ADDENDUM 1_April 11, 2024

RE: Addendum No. **One (1)** to the Bidding Documents for:
York Maintenance Facility Vehicle Storage Garage, Mile 6.8, York, ME

YORK VEHICLE STORAGE GARAGE

ADDENDUM #1 4-11-24

CONTRACT 2024.09
YORK VEHICLE STORAGE GARAGE
CODE COMPLIANCE & FIRST FLOOR PLANS

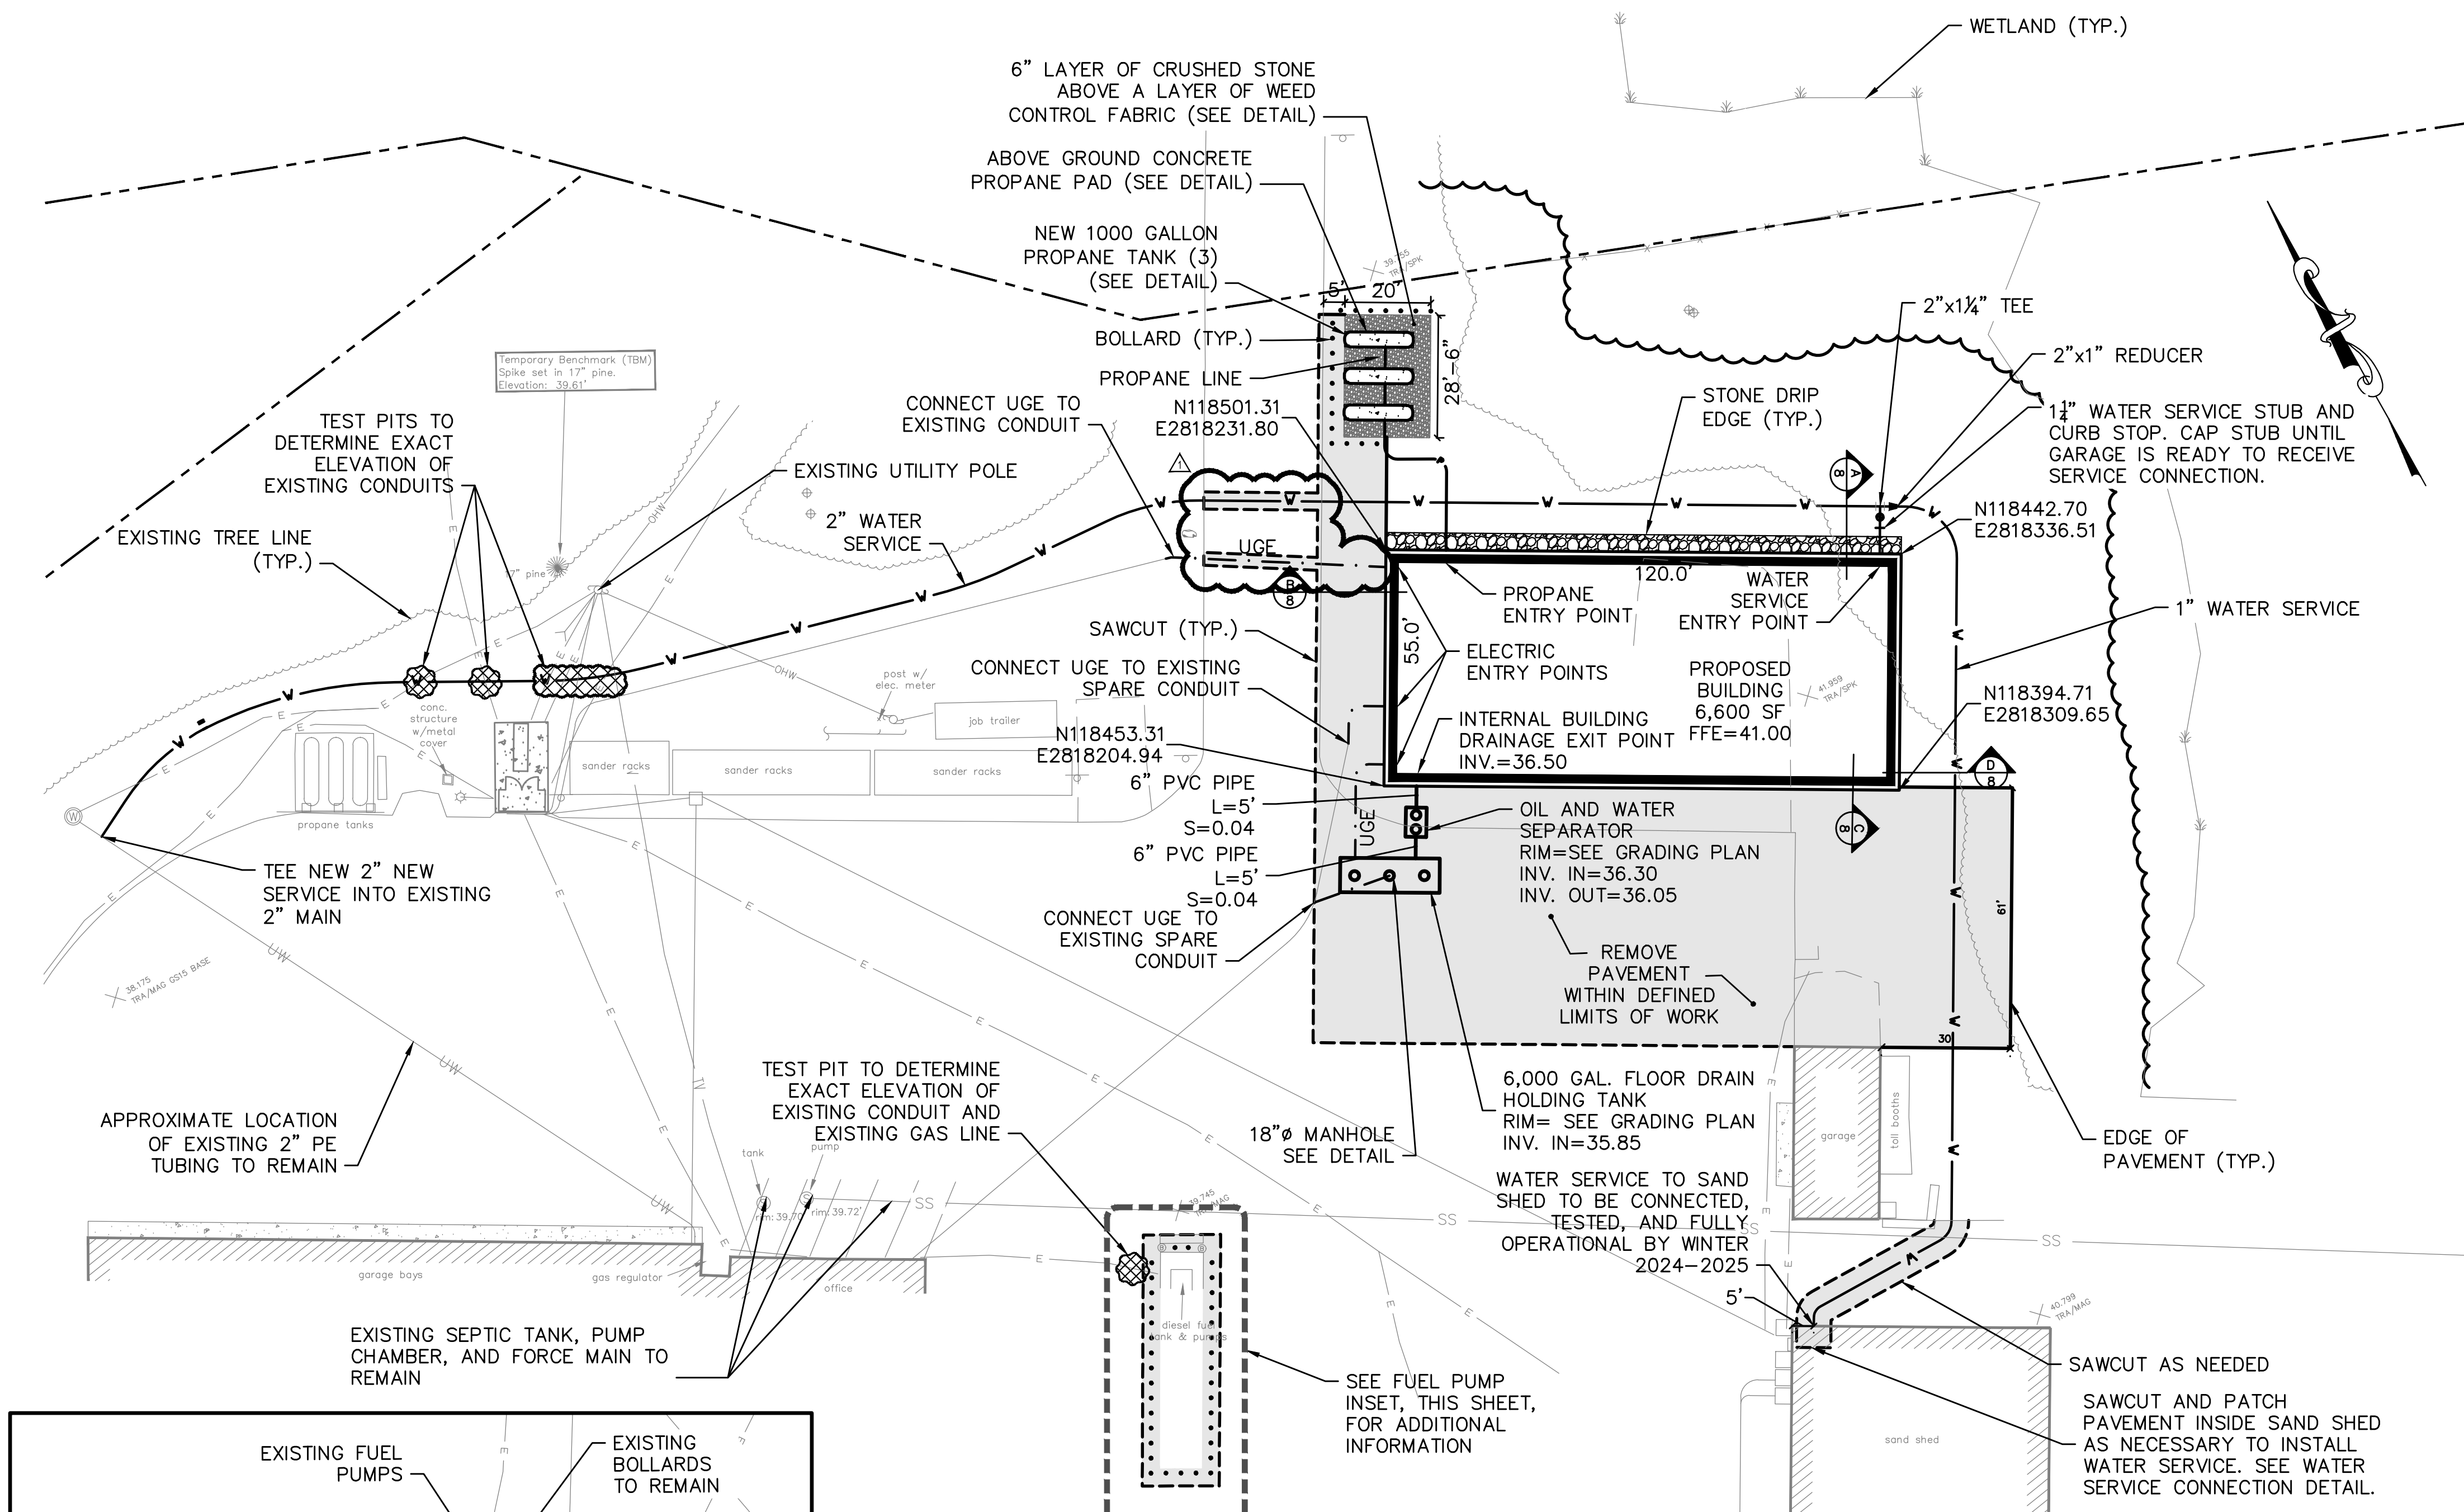
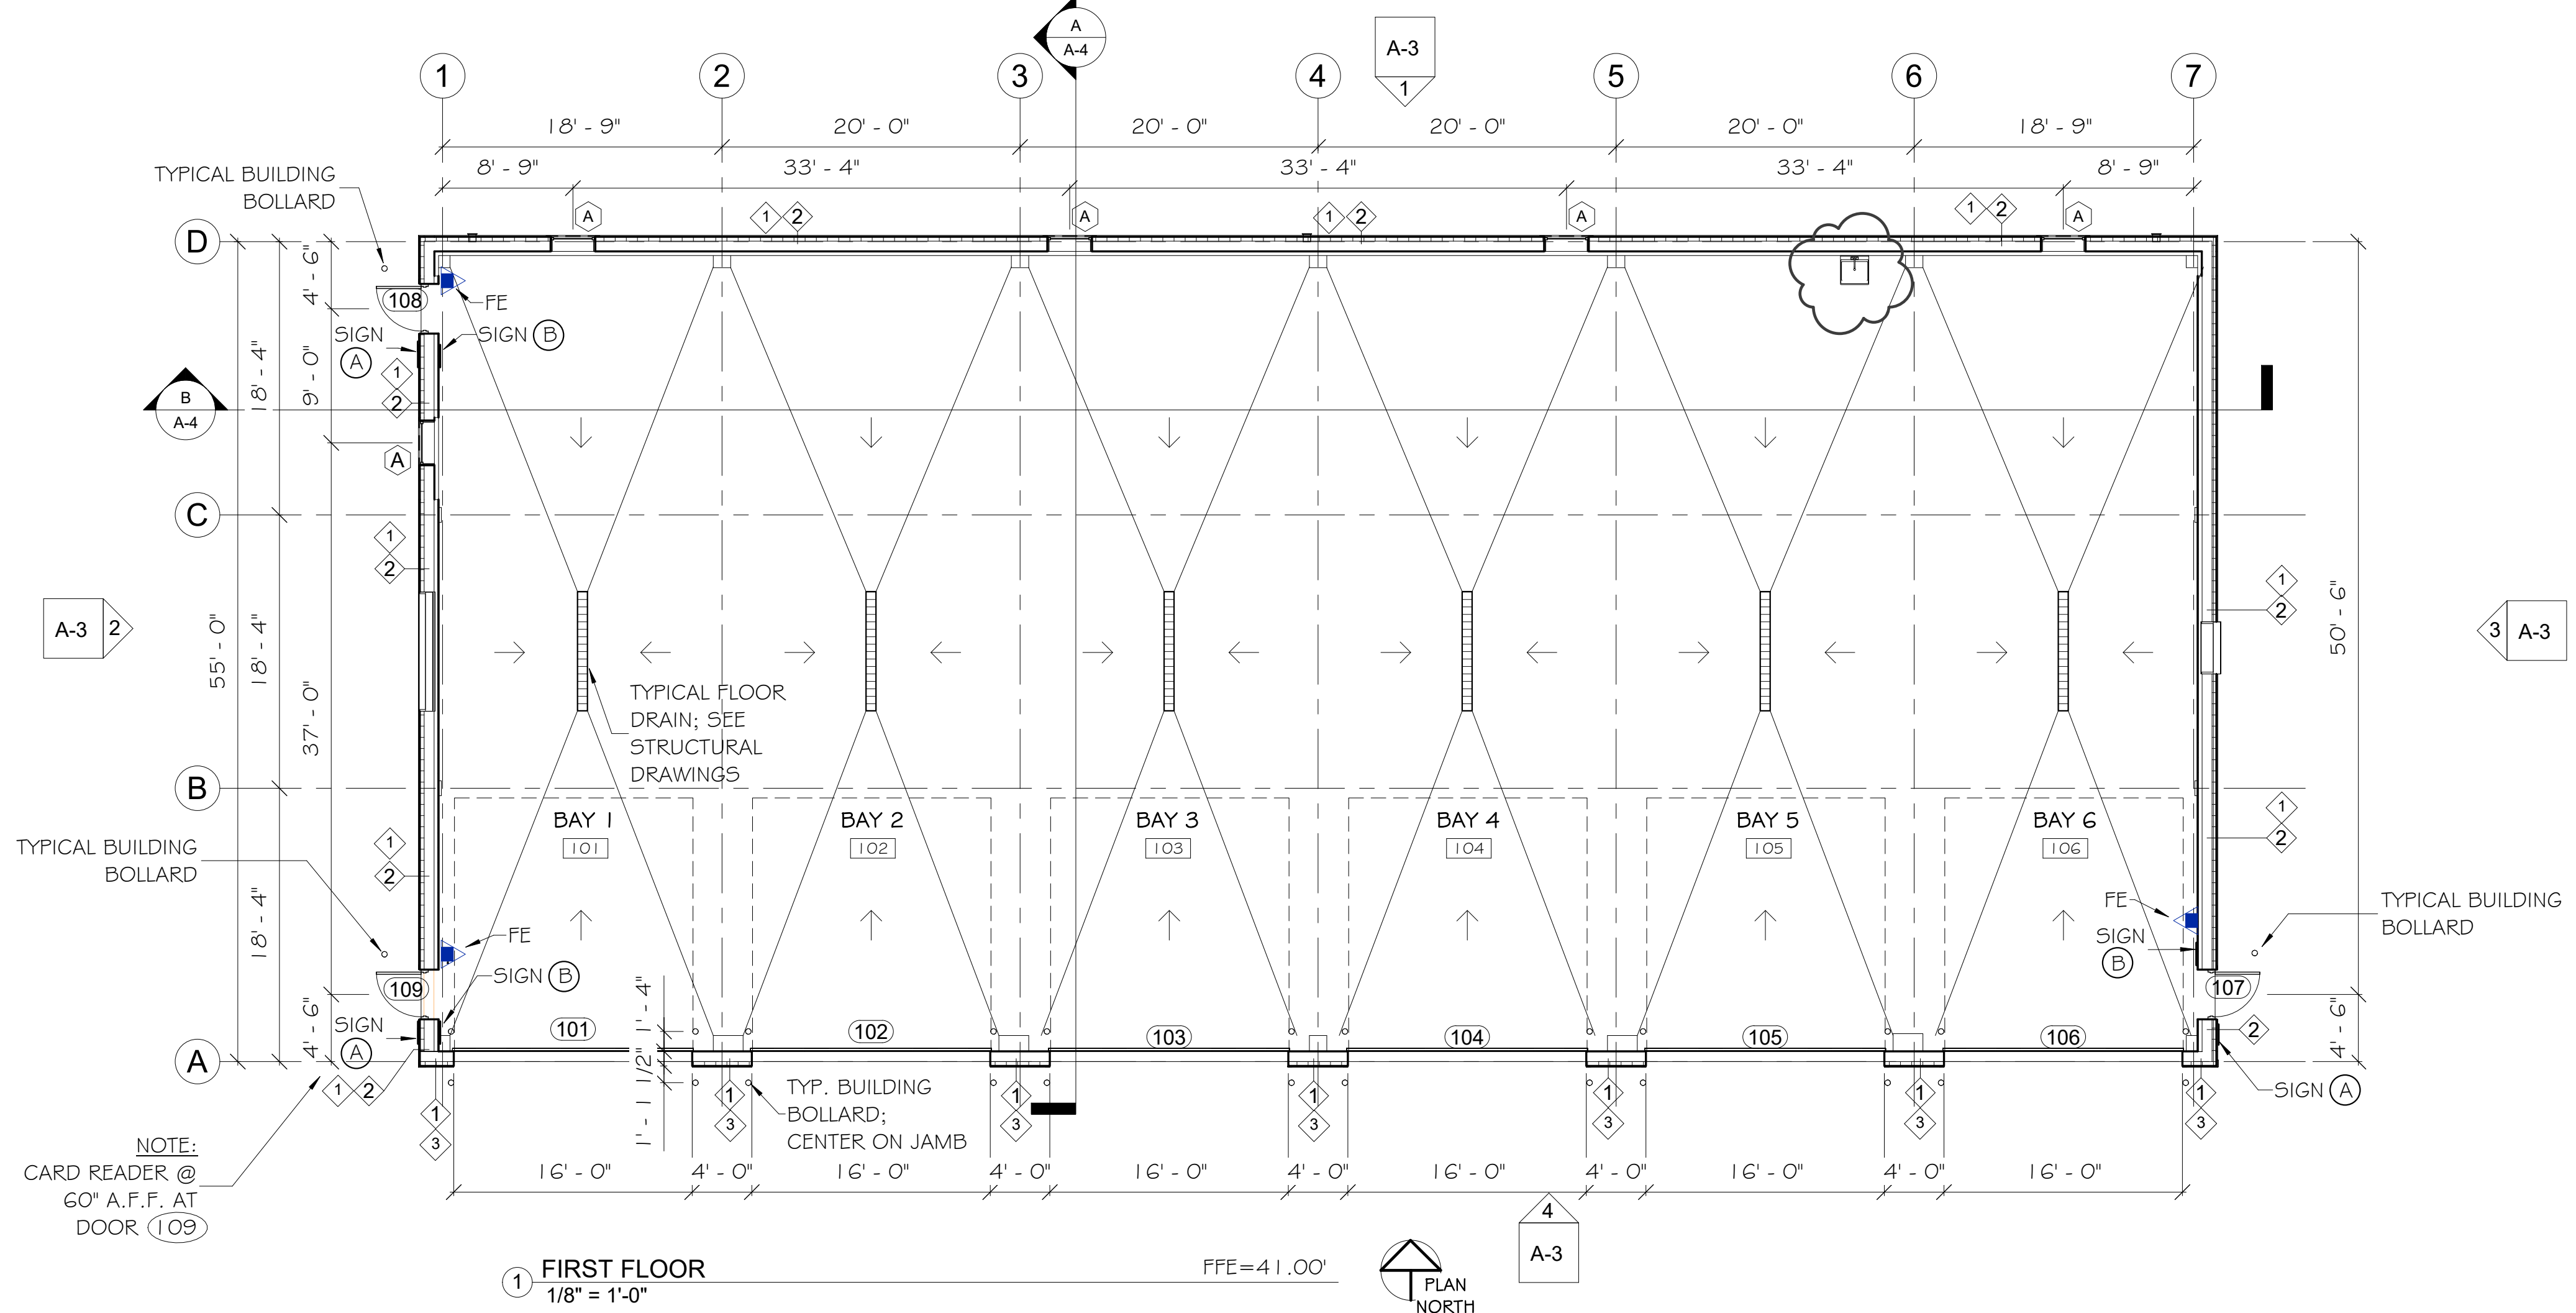
1. **Drawing A-7** The structural drawings are showing typical foundation wall to be 8” width. Detail 4/A-7 shows a 10” wall.
AEI Response: All foundation walls are 8" as shown on structural drawings.
2. **Drawing C-101 and C-401:** There appears to be a discrepancy between the propane tank dimensions indicated on the Site and Utility Plan C-101 & the Precast Propane Tank Pad detail on sheet C-401.
AEI Response: The detail on Sheet C401 has been revised so that the pad dimensions match those depicted on the Site Plan.
3. **Specification Section 033000:** Are the reinforcing bar supports in the slab required to be epoxy coated?
AEI Response: No, bolsters are not required to be epoxy coated.
4. **Specification Section 077200:** Specification includes a spec for Roof Curbs. I don’t see where this would pertain.
AEI Response: There are no roof curbs on this project.
